Chino Mines Company
Box 10
Bayard, NM 88023

March 22, 2012

Re: Response to Request for Additional Information,
Application for Modification of Waiver, Revision 10-1, Permit No. GR010RE

DRAWING	A-1	REVISION	B
FILE NAME	1008011D007

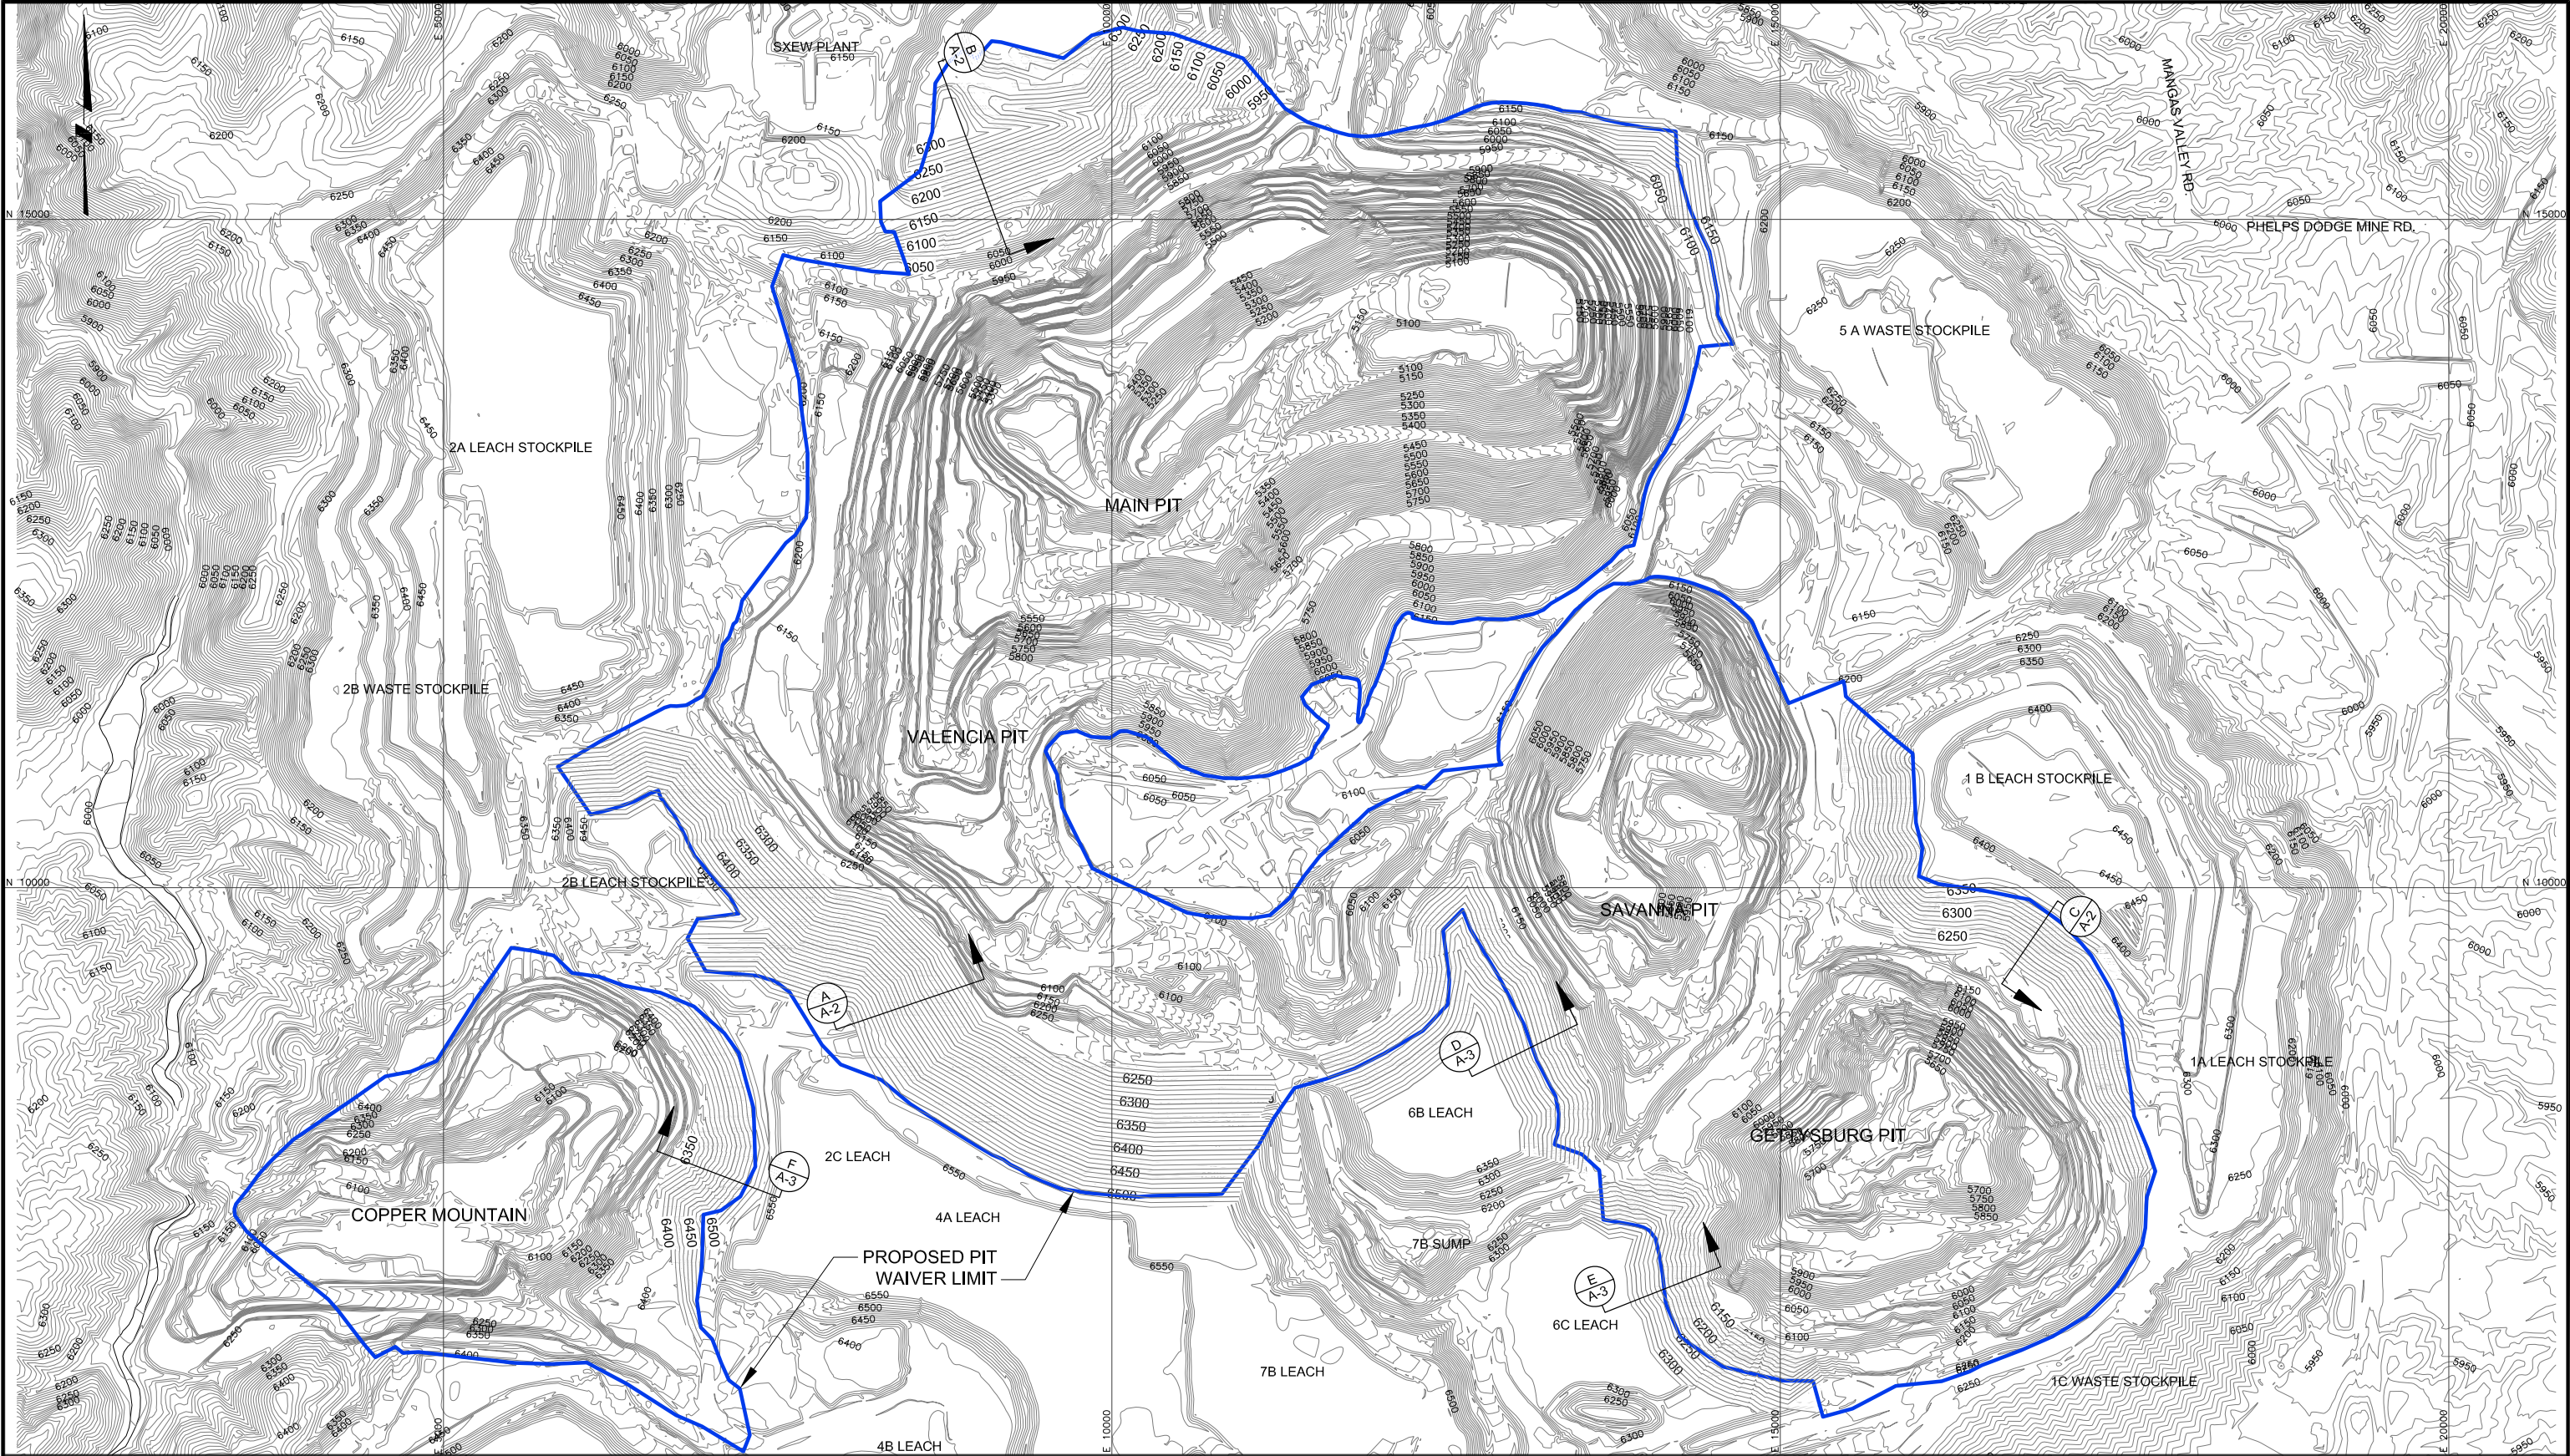
- 1) Figure 3 from the July 28, 2010 modification request which delineates the areas to be waived.
- 2) Drawings A-1, A-2 and A-3 from Attachment A of the July 28, 2010 modification request.
- 3) Figure 5 cross sections from the March 9, 2011 response to MMD comments.
